Re: Zircaloy Clad  
Conversion  
ISAP Topic 2.17

Haddam Neck Plant  
Additional Information  
Small-Break Loss of Coolant Accident Analysis--  
Zircaloy Clad Fuel

Attachment  
Haddam Neck Plant  
Additional Information

FIGURE 7-7

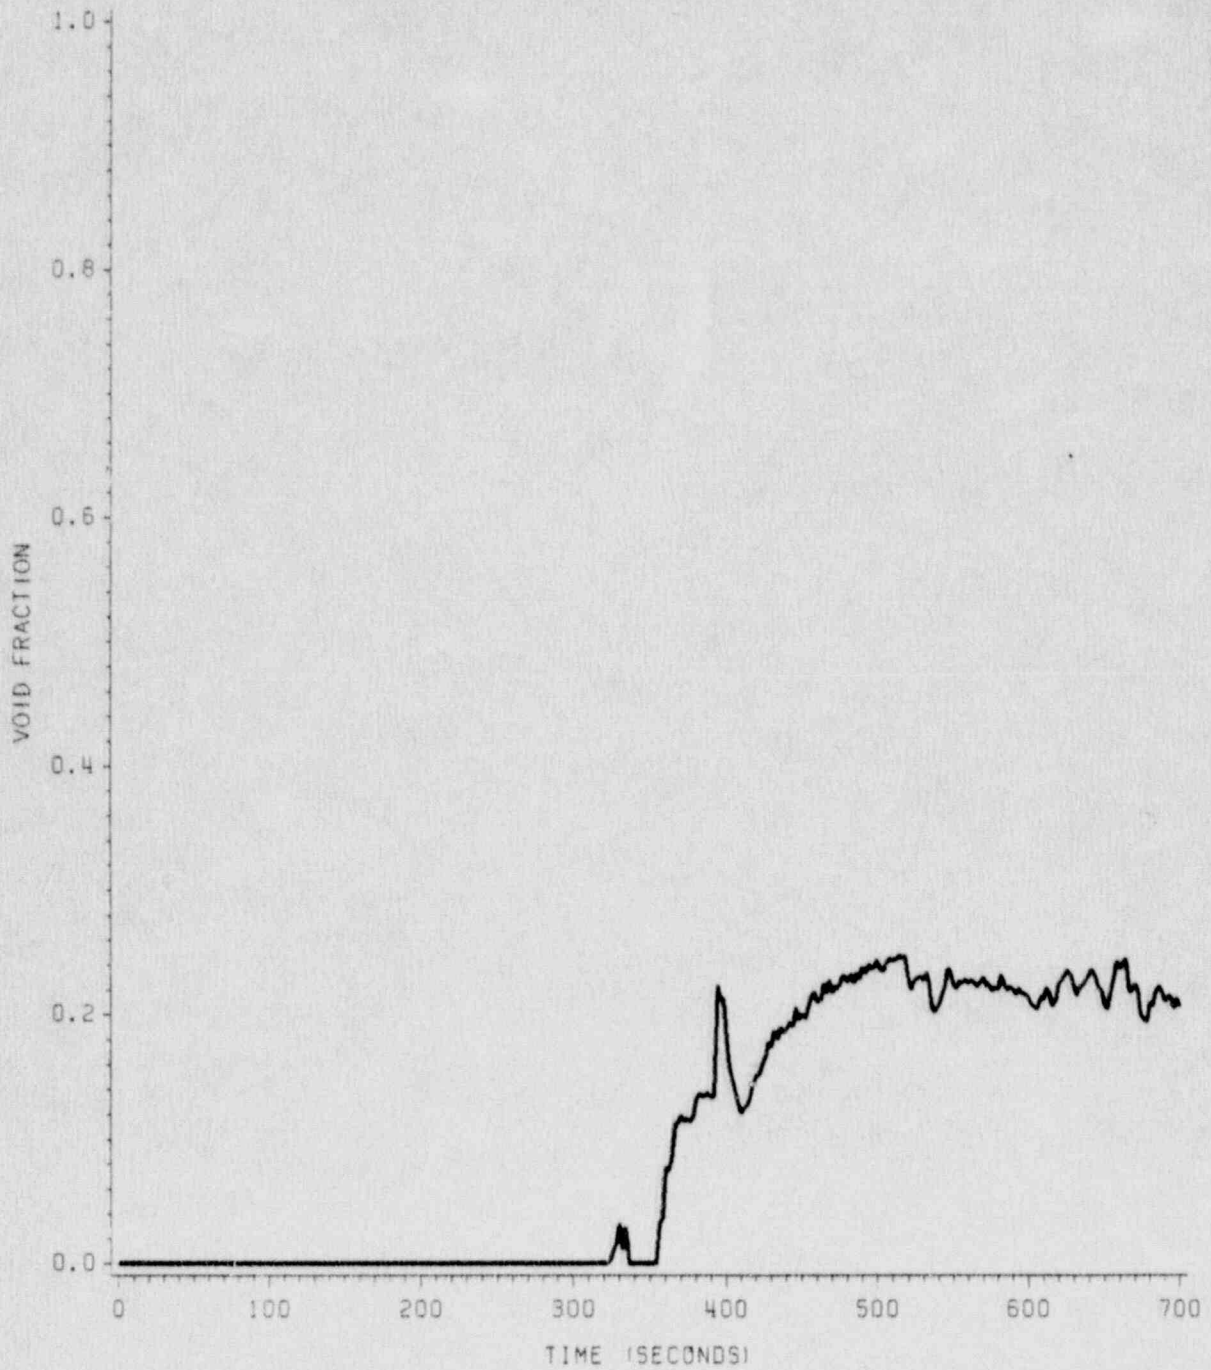
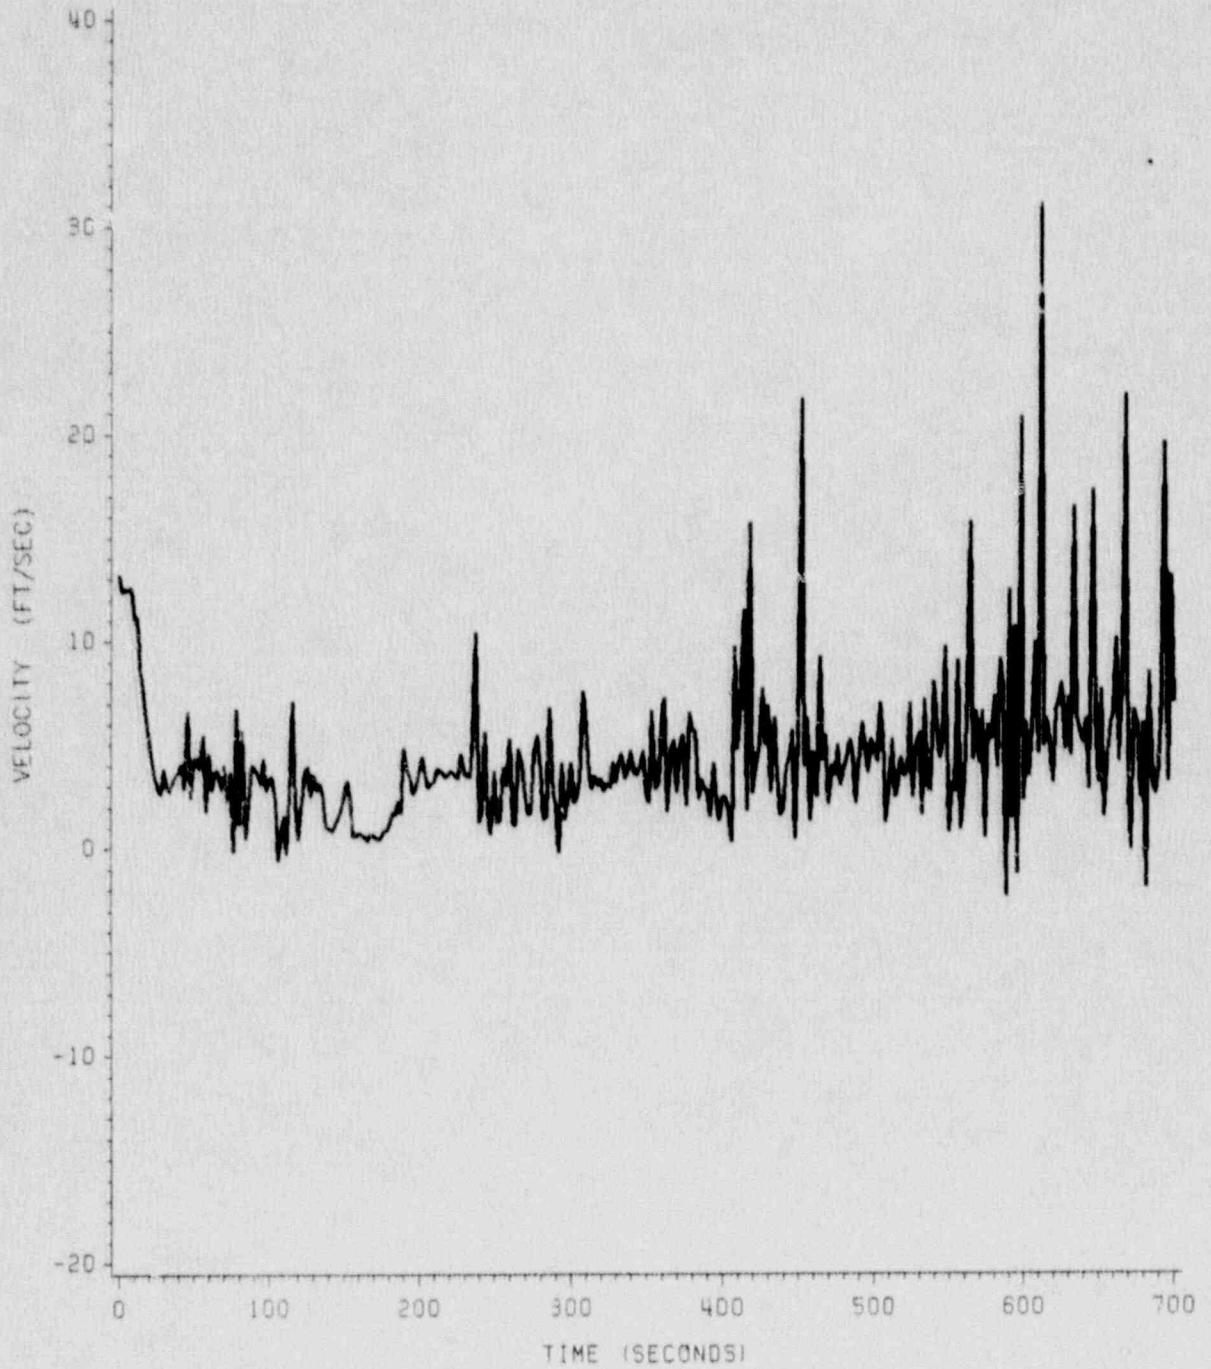
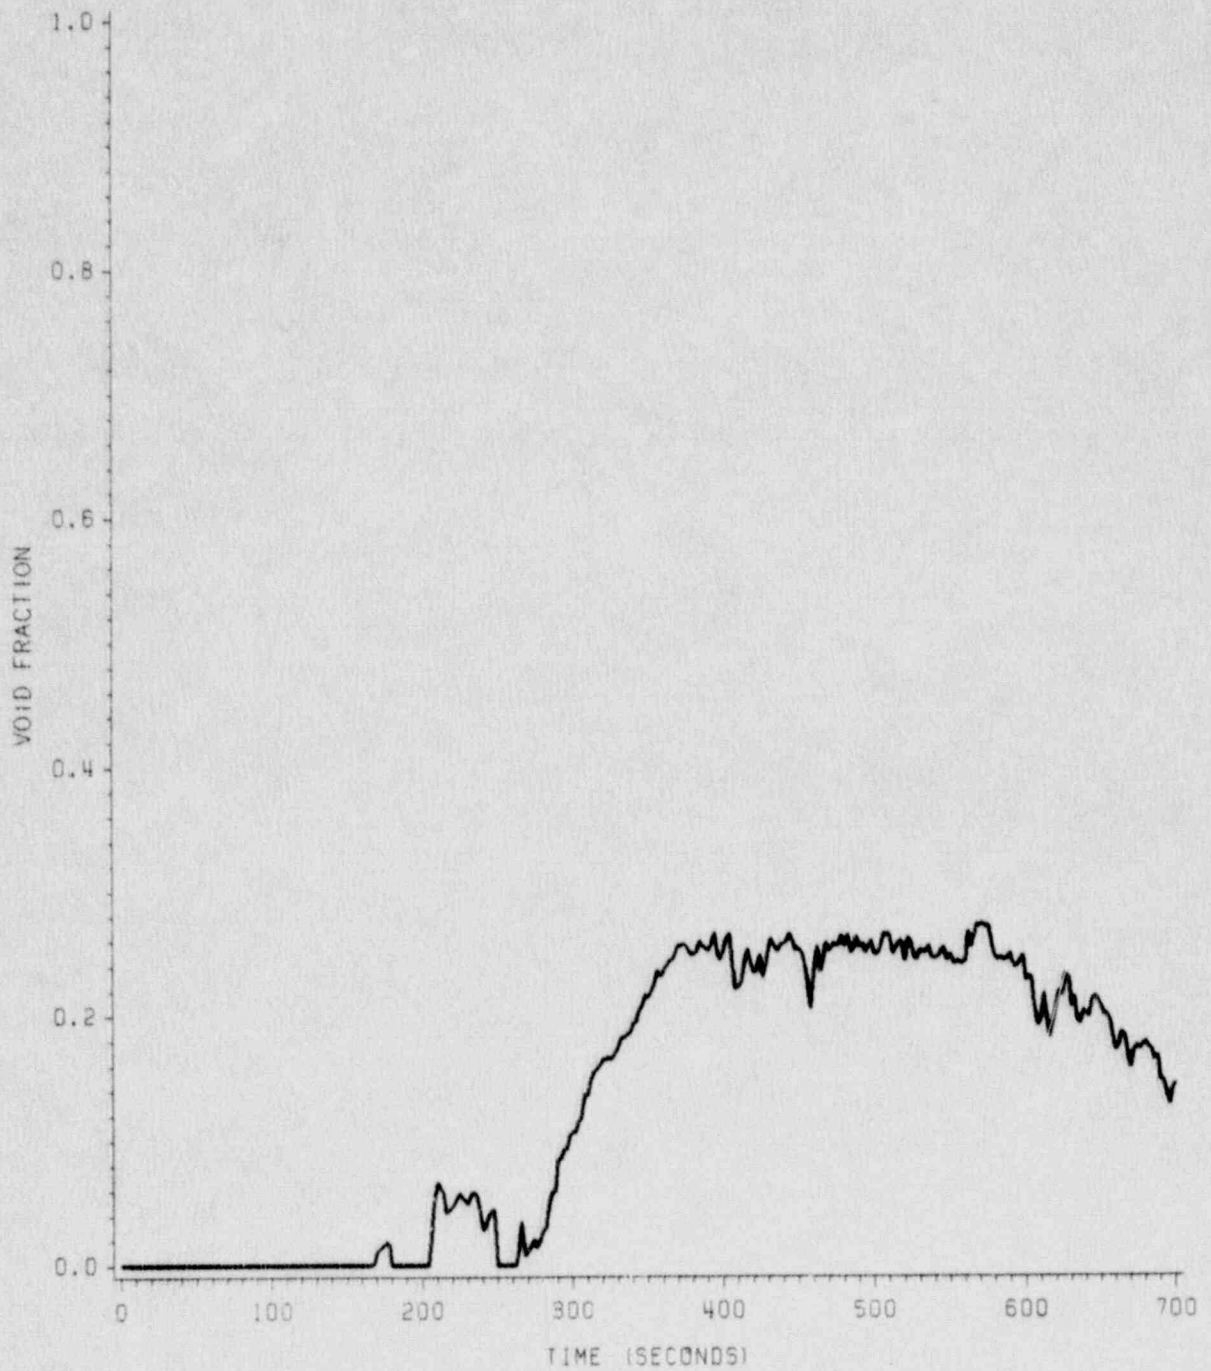
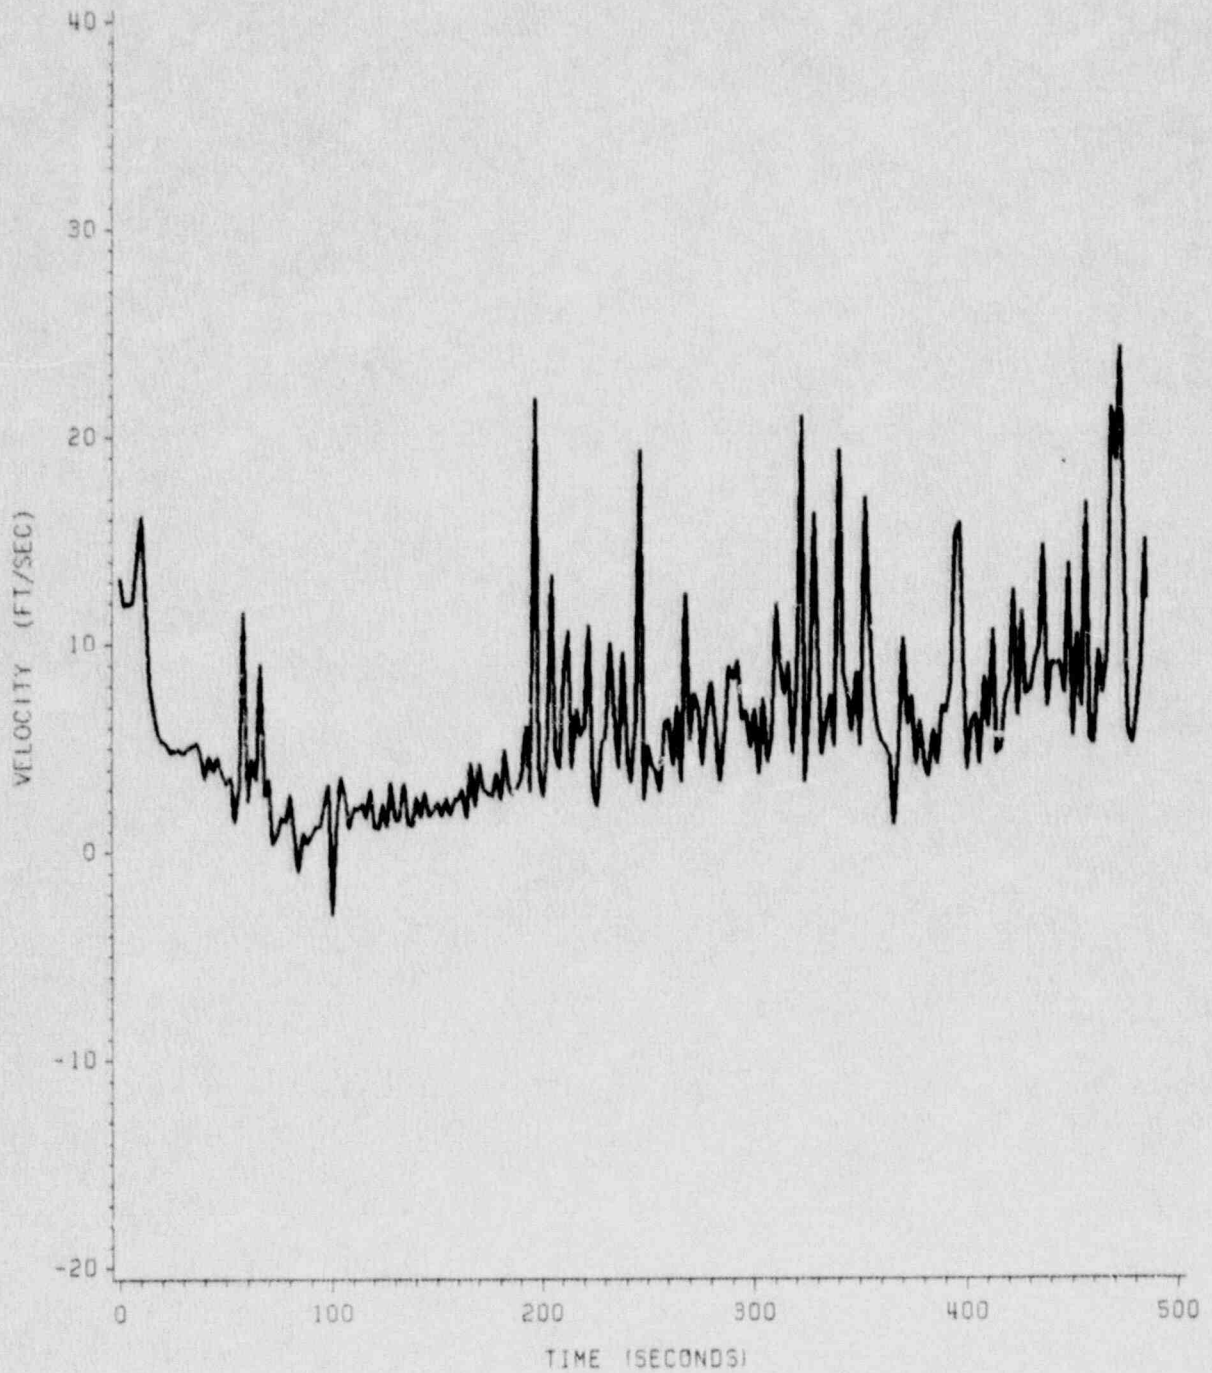
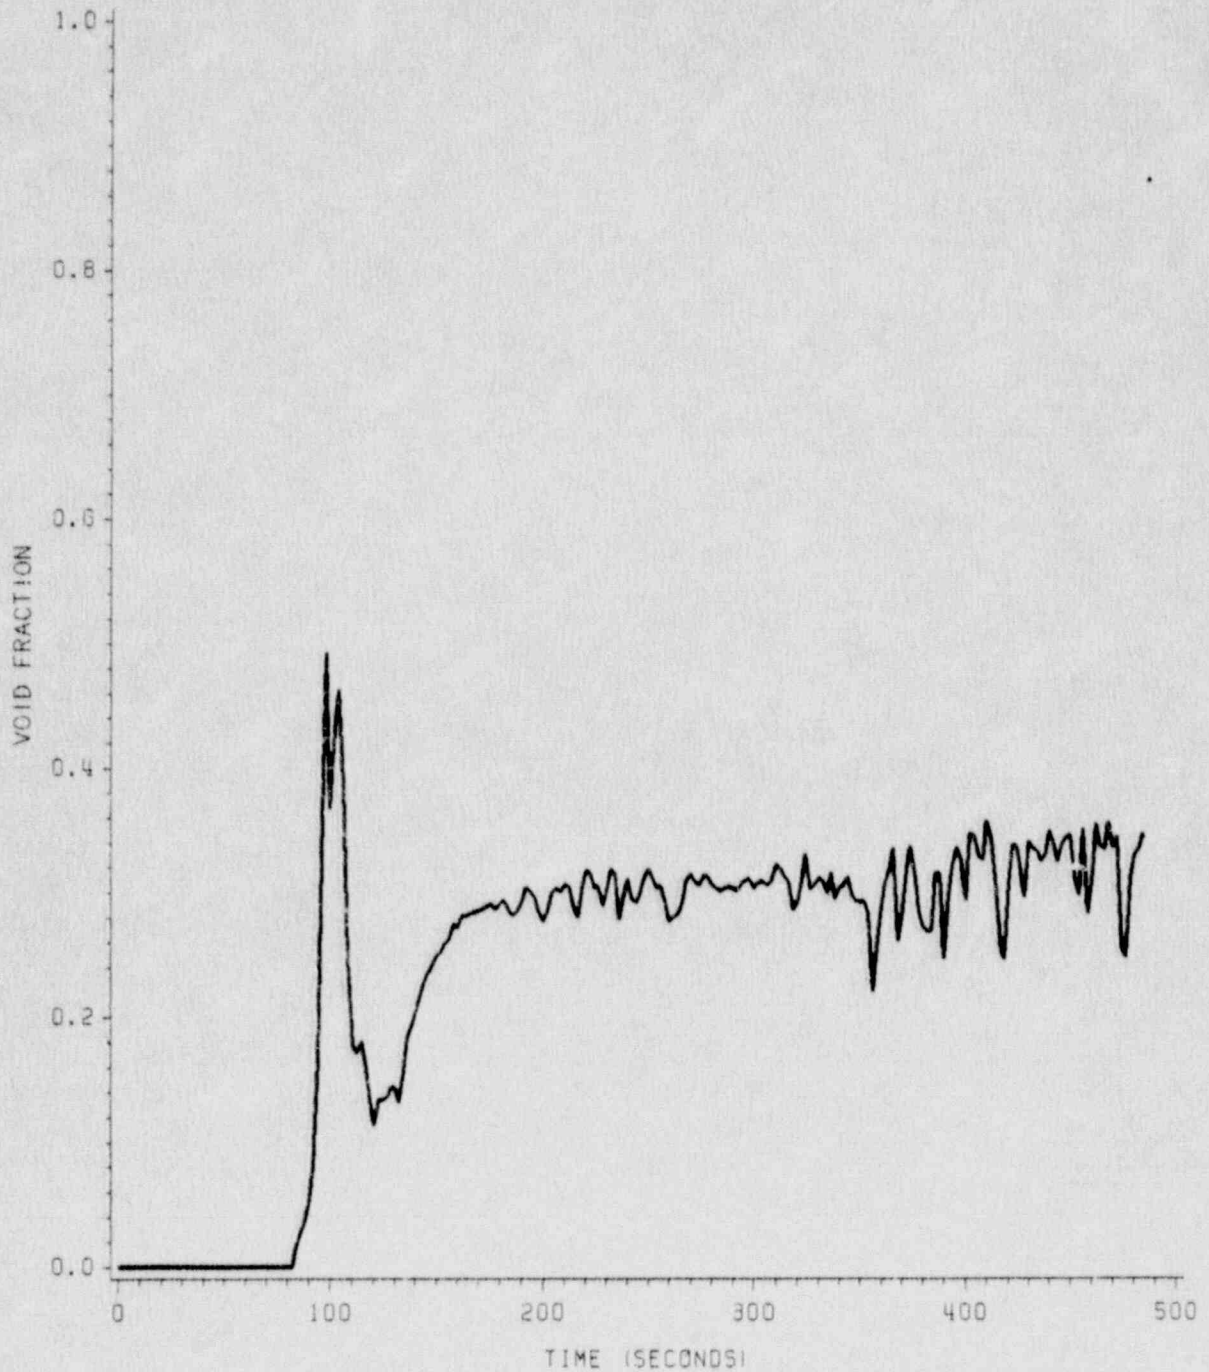
By letter dated August 3, 1988, the staff provided a safety evaluation of the use of the NULAP5 code. Conclusion 7 of the evaluation stated that the licensee committed to review the core thermal-hydraulics and clad temperature response in all future calculations to ensure that the clad temperature increase is not artificially terminated by the existence of mist flow in the upper core during the loop seal clearing uncovering period. Provide evidence of this review.

The clad surface temperatures are provided in NUSCO 163. Collapsed and two-phase level plots are provided in the response to Question 8. Figures 7-1 through 7-12 provide the hot spot vapor velocity and void fraction in lower plenum volume 335 for each of the breaks analyzed in NUSCO 163.

The collapsed and two-phase level plots provide the time frame for the loop seal clearing uncovering period. It can be seen from the clad temperature responses that the clad temperature increase is terminated during or subsequent to the core level recovery period following loop seal clearing for each of the breaks analyzed. In order to terminate the clad temperature increase during the loop seal clearing uncovering period, a sudden increase in hot spot vapor velocity would have to occur resulting in an increase in heat transfer coefficient. An increase in hot spot vapor velocity could potentially be calculated to occur if the lower plenum volume 335 significantly voided as core level approached the minimum value. Generally, the void fraction in volume 335 would have to be greater than approximately 0.6 for this phenomenon to occur. The lower plenum volume 335 void fraction plots provided verify that the void fraction never approaches 0.6 during the loop seal clearing uncovering period.

Based on the above, it was concluded that, for each of the breaks analyzed in NUSCO 163, the clad temperature increases were not artificially terminated by the existence of mist flow in the upper core during the loop seal clearing uncovering period and that no additional analysis was required.
